ERL Comment Update with New Data for Tx Hosts

Richard Mellitz, Samtec

04-18-2018 IEEE 802.3 50 Gb/s, 100 Gb/s, and 200 Gb/s Ethernet Task Force Electrical Ad-Hoc

D3.2 ERL Does Not Pass Tested Host Channels

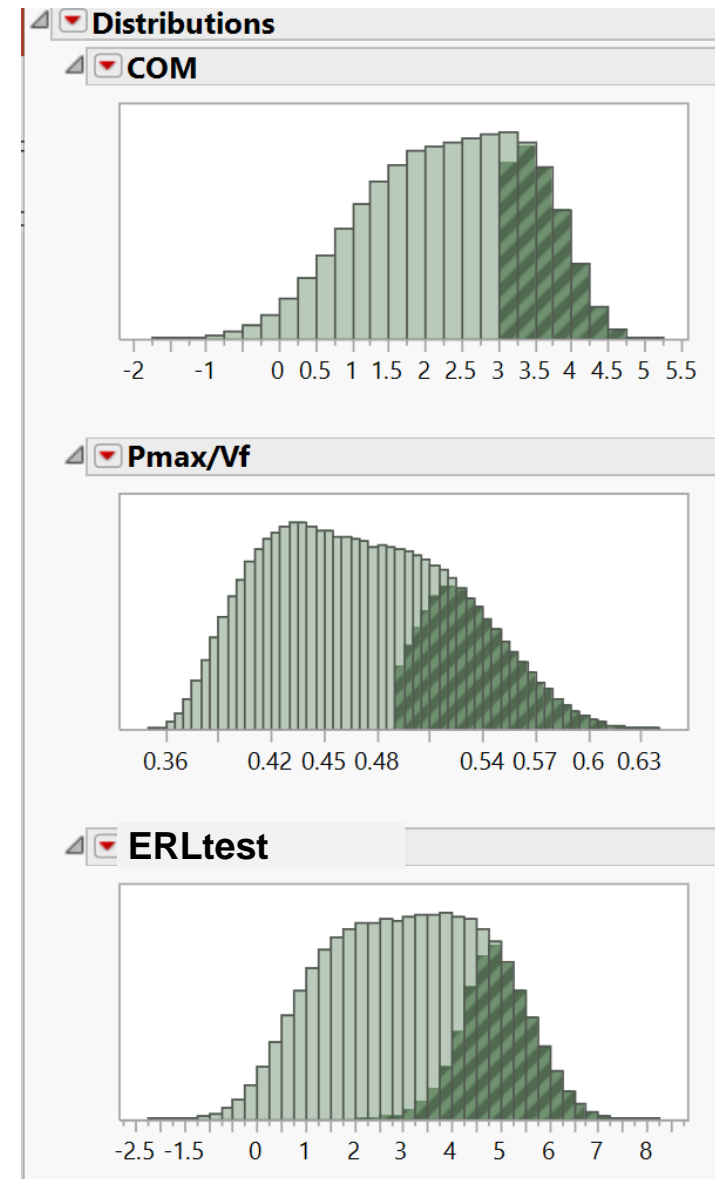
- ❑ Plot ERLtest for D3.2 (bottom distribution)
- ❑ Nothing in the population passes D3.2 ERL
 - Primarily due to the Grr equation
- ❑ Many designs pass COM for the cable assembly
- ❑ A change for Grr, β_x , ρ_x was suggested in
 - [mellitz_3cd_01a_032118_elect_adhoc](#)

Tx Host Test Results for ERLmin (limit): False Pass and False Fail

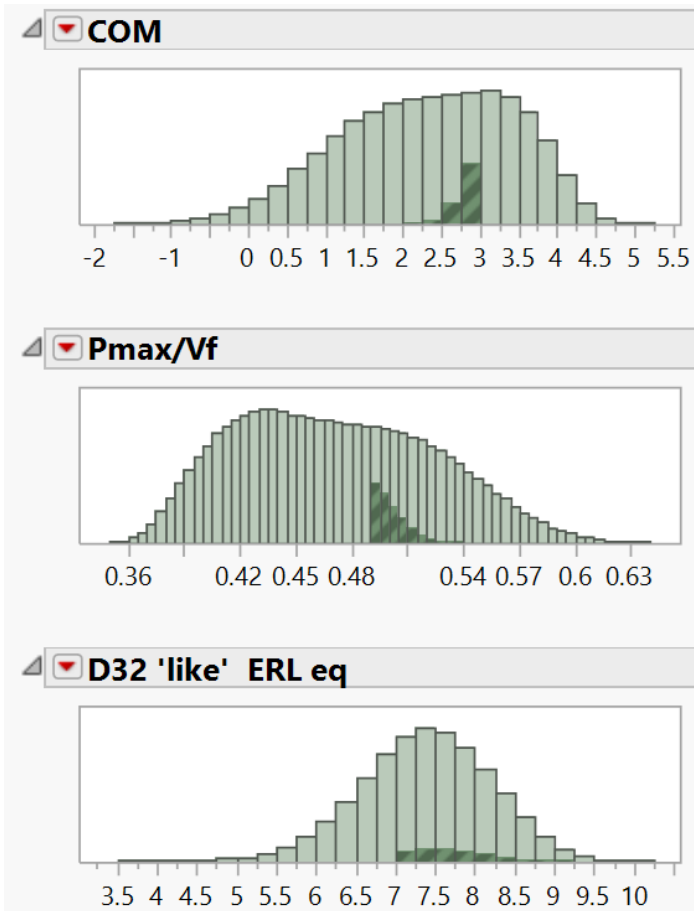
ERL min (dB)	False fail	False pass
16	30%	0%
14.5	28%	0.20%
13.5	16.30%	2.90%
13	9.50%	4.70%
12.5	4.40%	5.80%
12	1.50%	6.20%
11.5	0.40%	6.40%
11	0.06%	6.40%
0	0%	6.40%

Adjust the D3.2 “ $\log_{10}(P_{max}/V_f)$ ” ERL Term
(and G_{rr} , β_x , ρ_x)

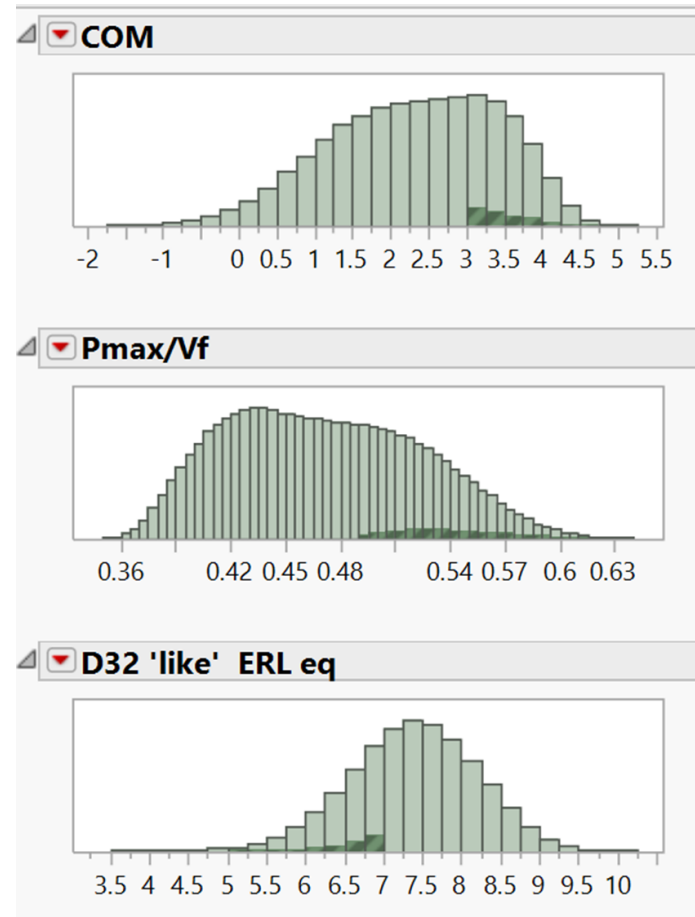
- ❑ Determine $ERL_{Tx_test} = ERL + 20 * \log_{10}(P_{max}/V_f)$
 - i.e. $ERL > ERL_{Tx_test} - 20 * \log_{10}(P_{max}/V_f)$
- ❑ Let's use the term
 - ERL_{Tx_test} similar to D3.2 ($ERL > 8 - 40 * \log_{10}(P_{max}/V_f)$)

ERL_{Tx_test} for D3.2 like eq	False fail	False Pass
9.5	30%	0%
9	28.8%	0%
8.5	24.2%	.1%
8	15.9%	0.97%
7.5	7.9%	2.8%
7	2.8%	4.9%
6.5	0.7%	5.8%
6	.1%	6.2%
5.5	0%	6.3%

- ❑ Recommend changes for and G_{rr} , β_x , ρ_x and N in slide 3 but consider the following options:
- ❑ Option 1:
 - $ERL_{Tx} > 7 - 20 \cdot \log_{10}(P_{\max}/V_f)$ dB
 - Requires fit measurements to determine pass/fail
 - Fit measurement alone have been shown to be a good indicator
 - $ERL_{Rx} > 12$ dB
- ❑ Option 2: Keep ERL for Tx and Rx the same
 - $ERL > 12$ dB
- ❑ No changes to COM and ERL computation required
- ❑ Configuration spreadsheets can be posted after meeting decision
